Bulletin Type.....: Safety Recall

Bulletin No.....: TS-S131

Bulletin Name.....: Nozzle Replacement

Subject:Firetrace fire suppression system nozzle replacement

FOR CE SYSTEMS (SYSTEMS USING NOZZLE P/N 500001 AS SHOWN ABOVE):

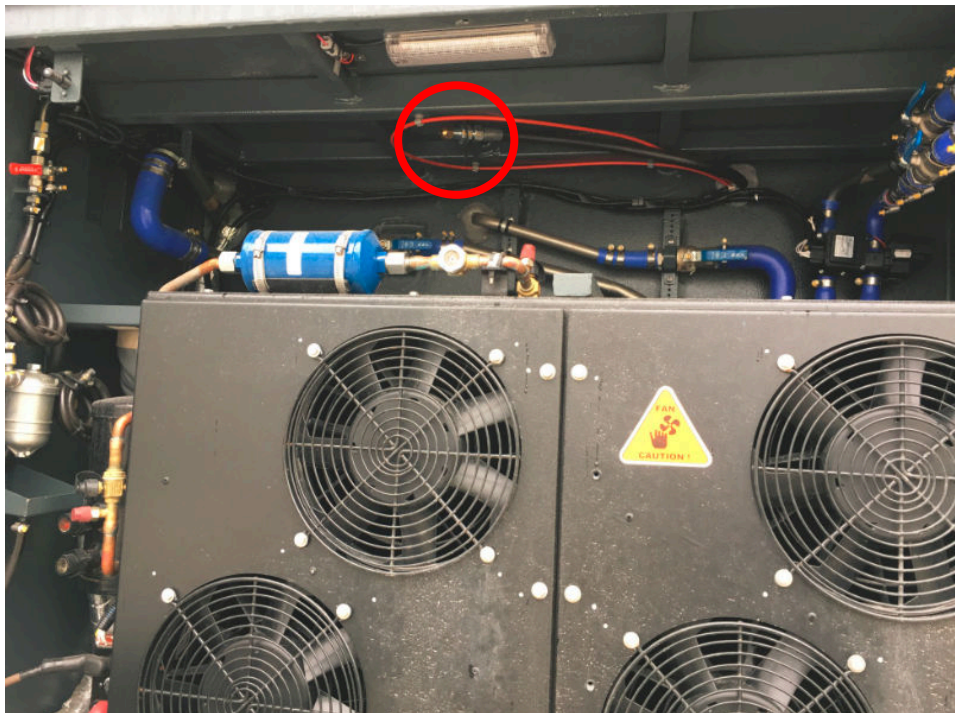
1. Remove the existing nozzle with a spanner (wrench) to remove the nozzle from the fitting whilst clamping the fitting to avoid disturbing other connections. Discard the nozzle.
2. (If applicable) Remove and discard the rubber cap on the nozzle.
3. Install the adapter, wrapping the male connections with PTFE tape. Use care to secure the fitting while tightening the adapter, hand tight plus 1.5 turns.
4. Install the nozzle, again using PTFE tape on the male connection. Use care to secure the fitting while tightening the nozzle on to the adapter, hand tight plus 1.5 turns.
5. (If applicable) The newly supplied nozzle cap may then be installed by first sliding the tether over the nozzle and then placing the cap in place over the nozzle.

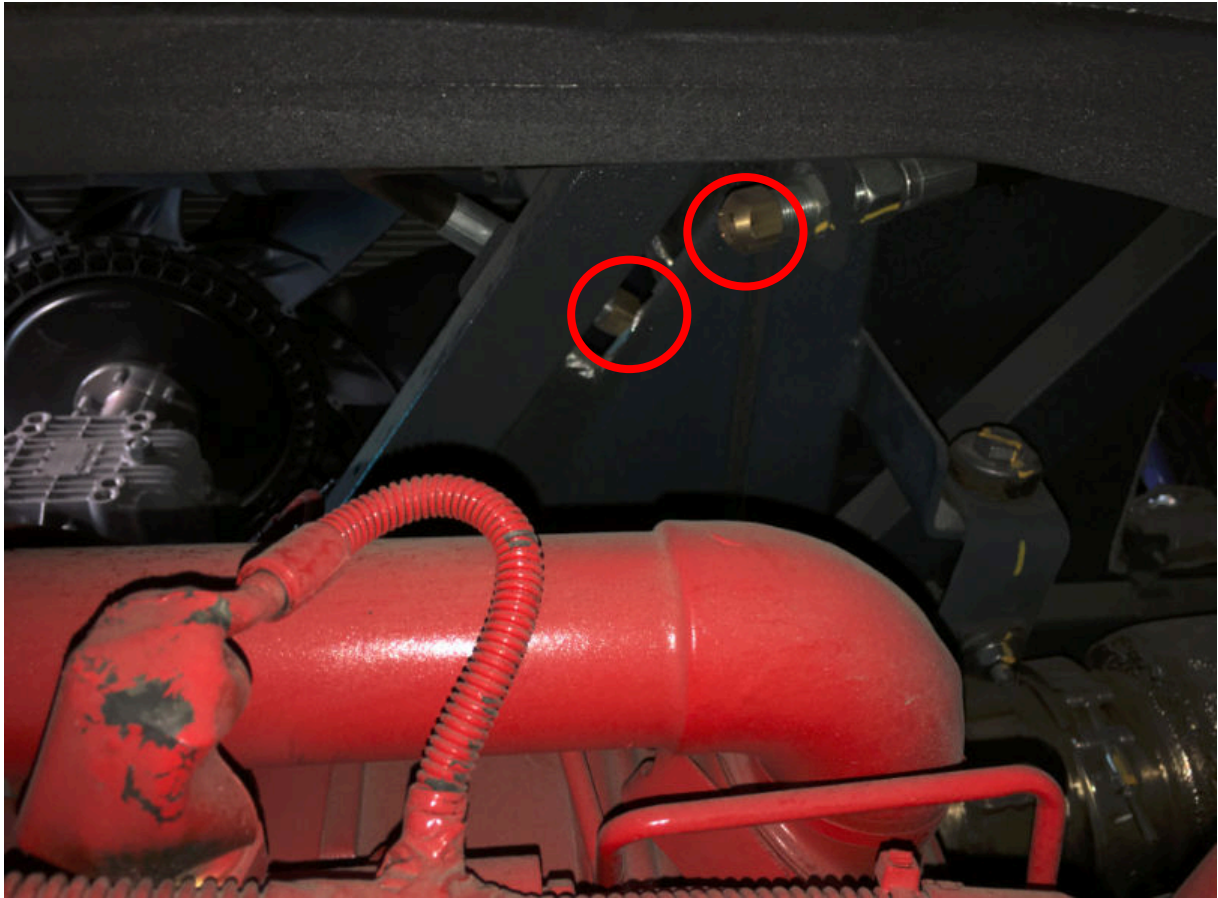
2. Nozzle 2,3 and 4 can be reached by opening the engine maintenance lid which is located at the end of the aisle;

2.a Bolts need to be unscrewed to reach out the nozzles;
